Subject: UniStar Nuclear Energy, NRC Docket No. 52-016  
Response to Request for Additional Information for the  
Calvert Cliffs Nuclear Power Plant, Unit 3,  
RAI 332, Ultimate Heat Sink

**Response to NRC Request for Additional Information,  
RAI 332, Question 09.02.05-22,  
Ultimate Heat Sink,  
Calvert Cliffs Nuclear Power Plant, Unit 3**

**Question 09.02.05-22**

**Figure 9.2-3— {Normal Makeup, Emergency Makeup, Blowdown & Chemical Treatment}**  
(Typical for each of 4 independent trains)

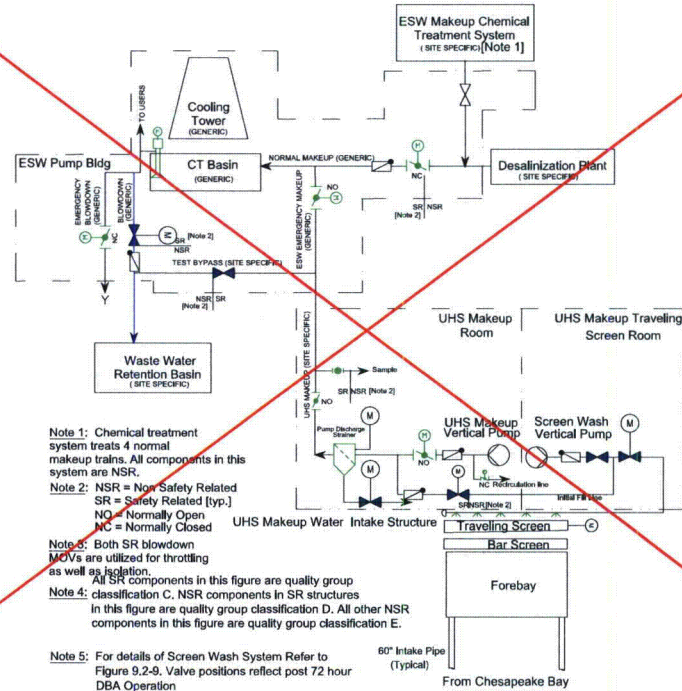
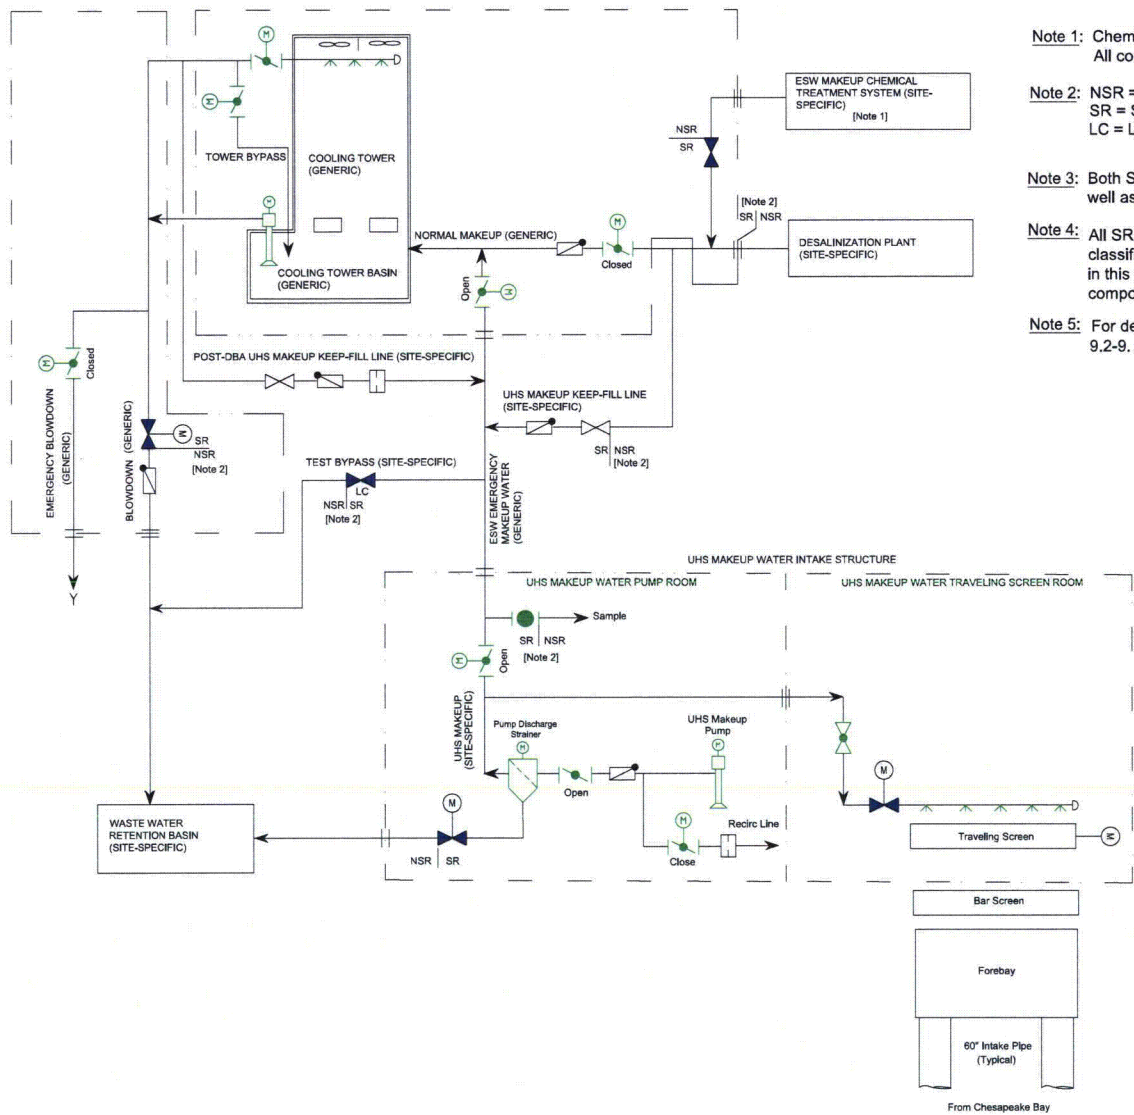
6. Clarify in the FSAR the valve positions and locations on an FSAR Figure, of the UHS makeup water system vent and drain valves to support the layup program and if these valves are open, describe the controls in place to maintain the system cleanliness. Describe in the FSAR the operator actions needed to close open valves.

The Post-DBA UHS Makeup Keep-Fill line piping and associated manual isolation valve, check valve, and flow restricting orifice are safety-related and identified in Section 1.8.2 as a departure from the U.S. EPR FSAR. (See Calvert Cliffs Nuclear Power Plant (CCNPP) Unit 3 Figure 9.2-3 – {Normal Makeup, UHS Makeup, and Blowdown} and

6. As discussed in the response to Item #4 above, the UHS Makeup Water System is changed to a wet layup configuration and the system is considered operationally ready at all times, including normal plant operation when the system is in standby. The system is full with Chesapeake Bay water, tested and ready to operate from the Control Room. The design of the UHS Makeup Water piping system incorporated vents and drains. During the standby mode or during system testing, vents and drains of the UHS Makeup Water System are in a closed position. Vents and drains will operate (open or closed) only during initial and maintenance system fill-up or maintenance drain-down. The location of vents and drains in the system will be determined during detail design.
